07/28/10	Added Note per Addendum 3
DATE	REVISION

STATE OF HAWAII
DEPARTMENT OF TRANSPORTATION
HIGHWAYS DIVISION
SITE PLAN
SITE 10 - MP 30.8
EMERGENCY EARTHQUAKE ROCKFALL REPAIRS
VARIOUS LOCATIONS ON HAWAII, UNIT 4
Federal Aid Project No. ER-15(22)
Scale: As Shown Date: December 2009
SHEET No. 6-10.1 OF 5 SHEETS

"AS-BUILT"

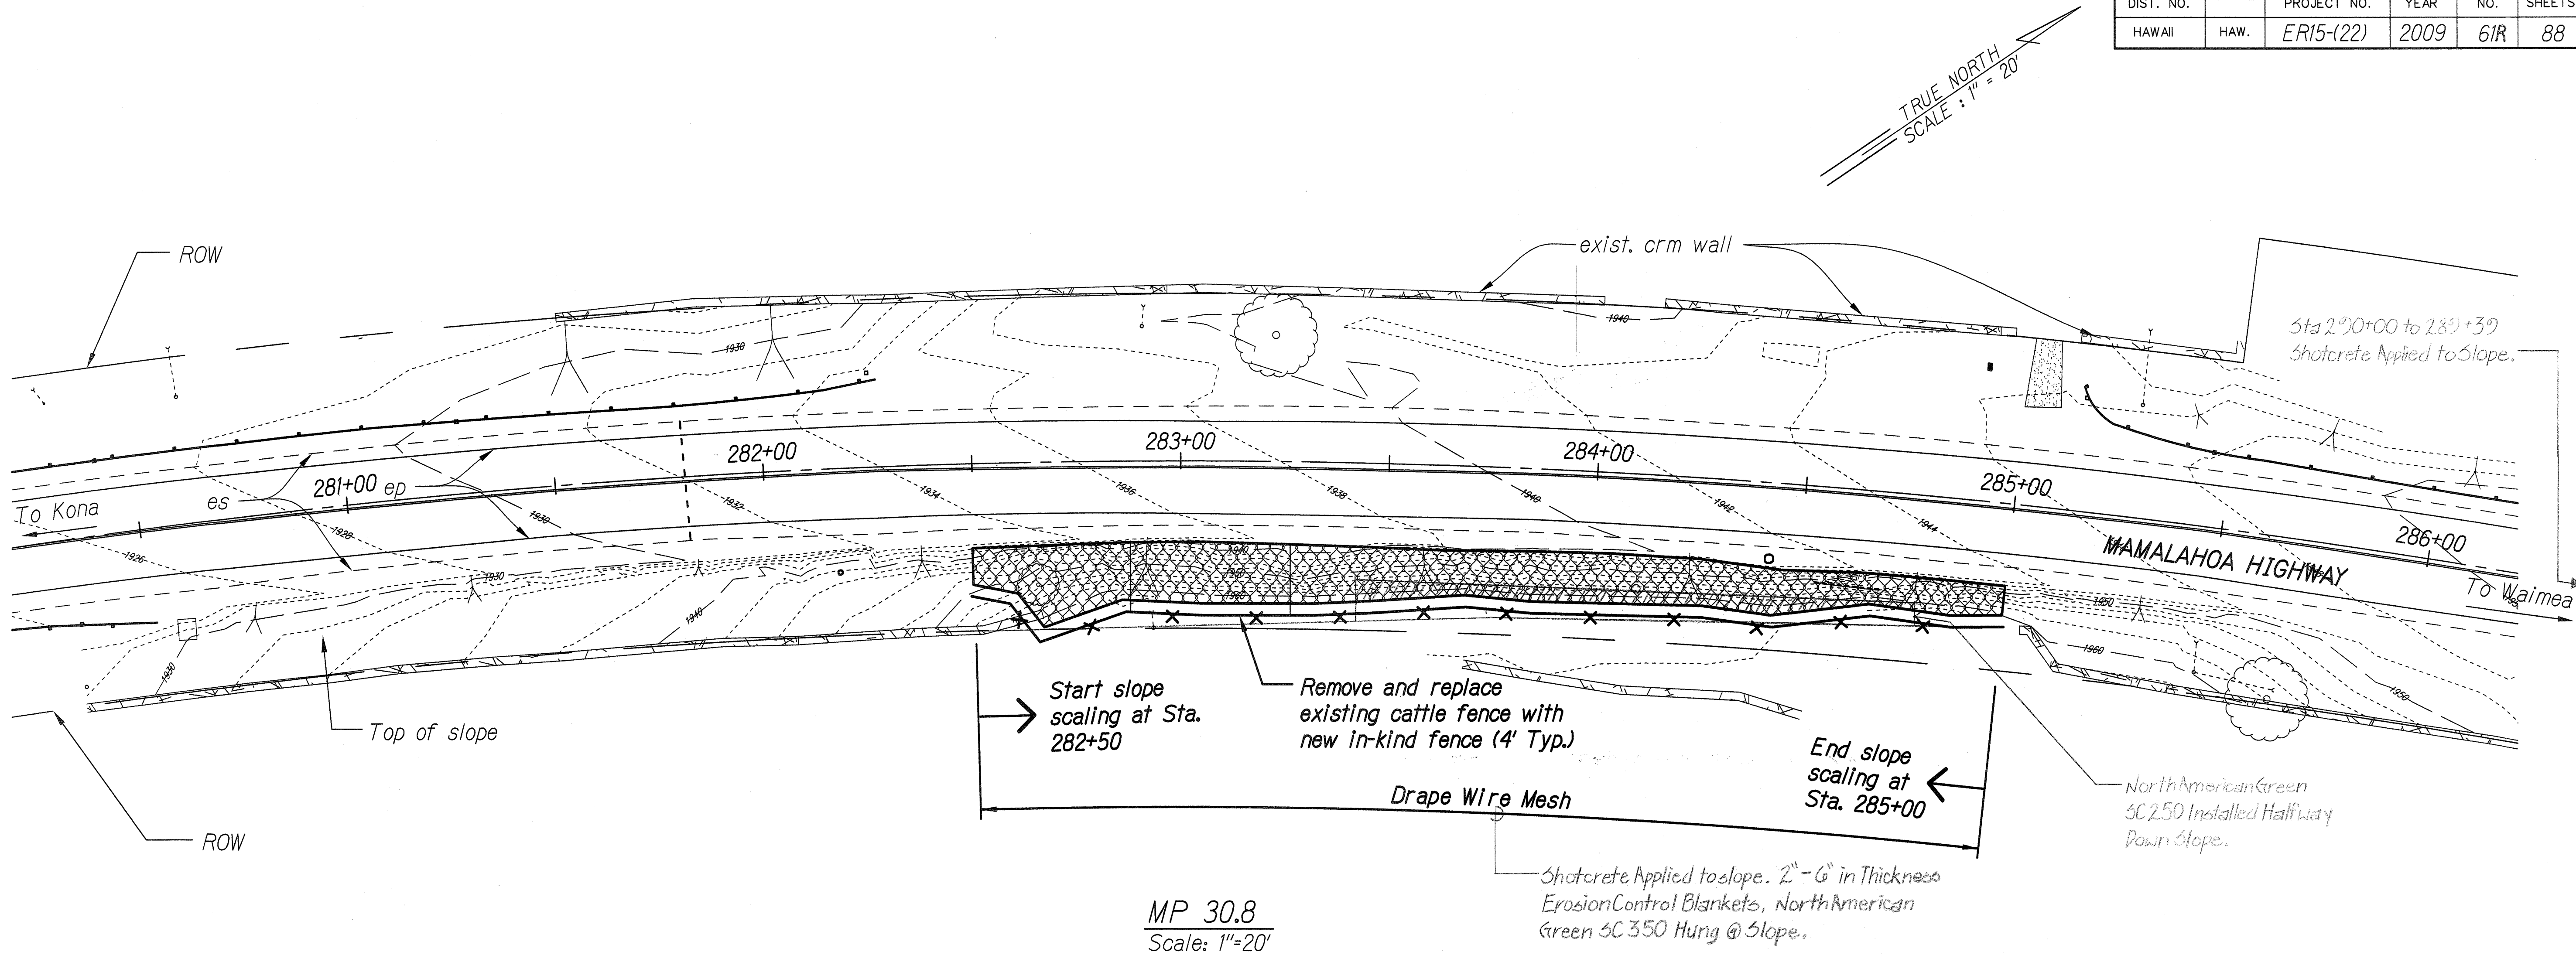
⚠ Note: Sta. 282+00 to 285+50 Rt.
Remove and Replace Existing e.p 4"
White Stripe with Type "C"
Markers at 40' o.c.
